# MANDATORY SERVICE BULLETIN

## NO. MSB-42-043/1

Replacement of aileron bellcrank located in the wing, with a bellcrank that allows for additional angular movement of the push rod, and replacement of a bent rod end.

DA 42 Twin Star

**Figure 1:** Aileron Controls in the Wing (colored items are affected by this SB)

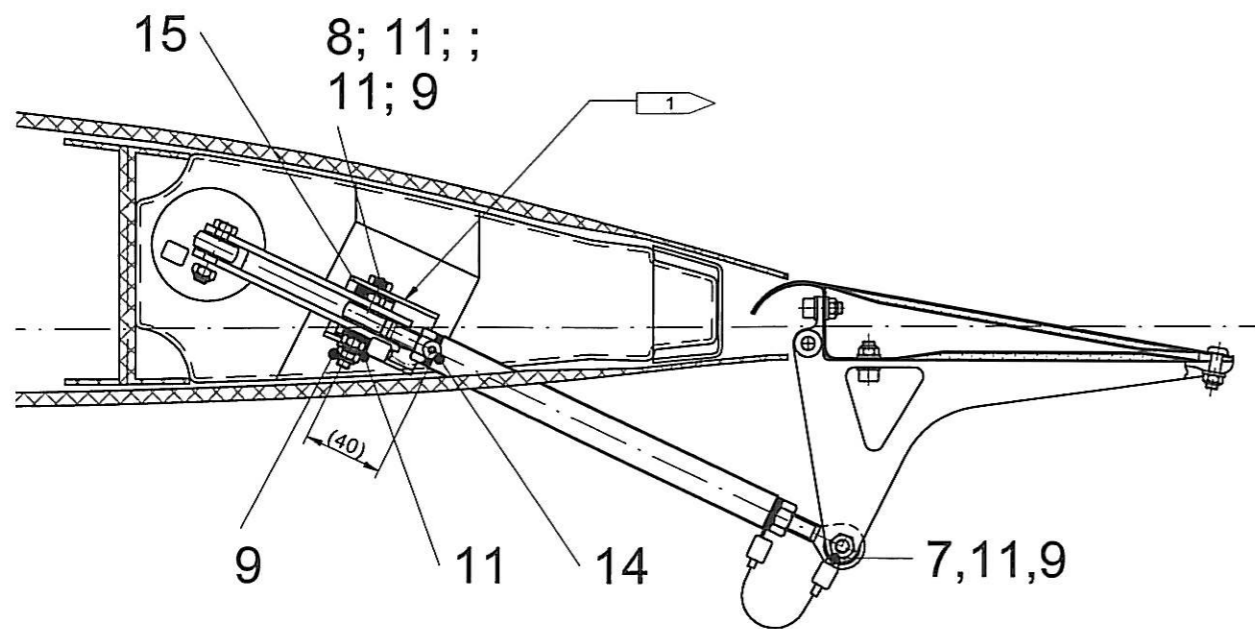
Rod ends in the aileron control system were slightly bent to achieve clearance. This non-preferable practice became obsolete, since a new design of the aileron bellcrank is available. This service bulletin calls for replacement of the bent rod end and the installation of the new design aileron bellcrank.

1.	Disconnect/Remove aileron push rods from the bellcrank.
2.	Record adjusted length of the short pushrod (from the aileron bellcrank to the aileron horn).

3.	Replace aileron bellcrank, refer to AMM section 27-00-00. <b>NOTE:</b> Keep bolt and washers, replace self-locking nut.
4.	Replace bent rod end (eye-end fitting with spherical bearing) and adjust to correct length, refer to AMM section 27-00-00. <b>CAUTION:</b> The thread of the rod end must be in safety.

5.	Install Bonding Sheet and reconnect/reinstall the push rods to the bellcrank using the LN 9037-M6x32 bolts and a new self-locking nuts. Refer to drawing D60-2717-00-00 and AMM section 27-10-00.
